RE: Case No. 2020-00280
ELECTRONIC APPLICATION OF ASHWOOD SOLAR I, LLC FOR A
CERTIFICATE OF CONSTRUCTION FOR AN APPROXIMATELY 86
MEGAWATT MERCHANT ELECTRIC SOLAR GENERATING FACILITY IN LYON
COUNTY, KENTUCKY PURSUANT TO KRS 278.700 AND 807 KAR 5:110

Review and Evaluation of Ashwood Solar 1, LLC Siting Assessment Report

FINAL REPORT

April 6, 2021

Figure C-1, Aerial View of Proposed Site and Surrounding Land Uses.

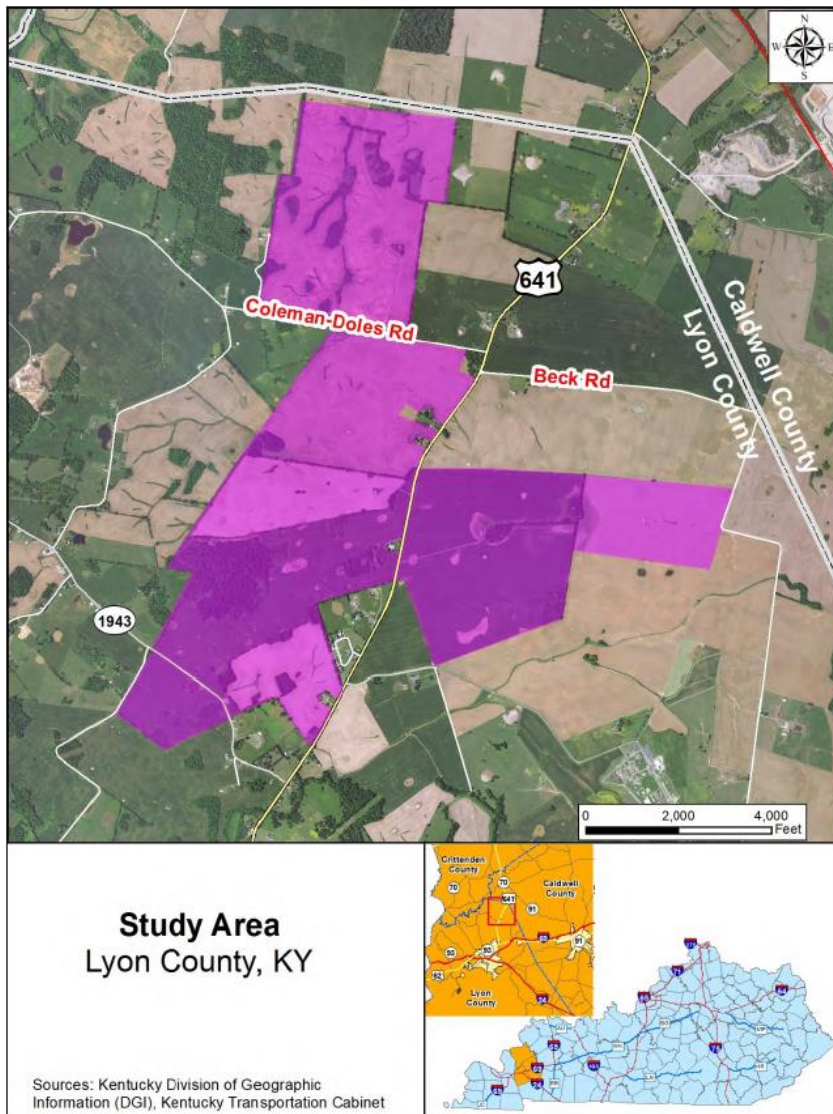
The proposed project site covers an area of approximately 1,500 acres. Most of the site is located west of US 641, north of KY 1943, and south of Coleman-Doles Road. A smaller portion is located east of US 641 and south of Beck Road, another smaller segment is located south of KY 1943 and an additional segment is located north of Coleman Doles Road and south of the Caldwell County border (Figure C-1).
